14. DESCRIPTION OF AMENDMENT/MODIFICATION (Organized by UCF section headings, including solicitation/contract subject matter where feasible.)  N40085-15-Q-7525 REMOVAL OF HEAT PUMP AND REPLACE WITH 12.5 TON SPLIT SYSTEM OF EQUIVALENT SPECIFICATION IN BLDG 77H AT THE PHILADELPHIA NAVAL BUSINESS CENTER, PHILADELPHIA, PA.  THIS AMENDMENT MUST BE ACKNOWLEDGED WITH RECEIPT OF QUOTE.  Description continues on page 2.				
Except as provided herein, all terms and conditions of the document referenced in Item 9A or 10A, as heretofore changed, remains unchanged and in full force and effect.				
15A. NAME AND TITLE OF SIGNER (Type or print)			16A. NAME AND TITLE OF CONTRACTING OFFICER (Type or print) SHANNON MACK / CONTRACT SPECIALIST TEL: 215-897-3495 EMAIL: shannon.mack@navy.mil	
15B. CONTRACTOR/OFFEROR  (Signature of person authorized to sign)		15C. DATE SIGNED	16B. UNITED STATES OF AMERICA BY _____ (Signature of Contracting Officer)

AMENDMENT 0002

**WEST BUILDING ELEVATION**  
SCALE: 1/8" = 1'-0"  
A1A3 2

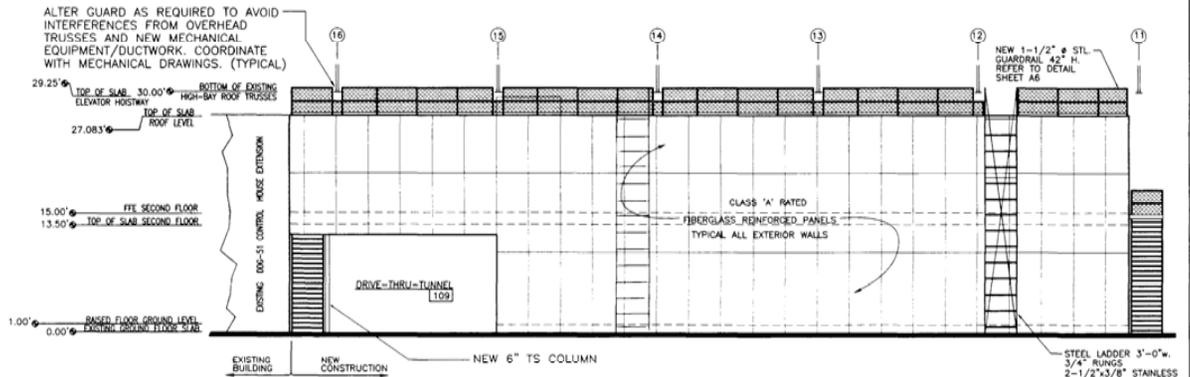
- Q4. Who is a POC at Automated Logics.  
**A4. Radius Control Systems.  
Anne Jennings  
484-844-3323**
  - Q5. The contract calls for 100% outside air capability, please advise which of the two options are acceptable?

- a.)Through the roof deck above the unit location
    - b.)Through the side exterior of the building.**A5. The outside air intake penetration point shall be through the West side of the building and NOT penetrate the roof.**
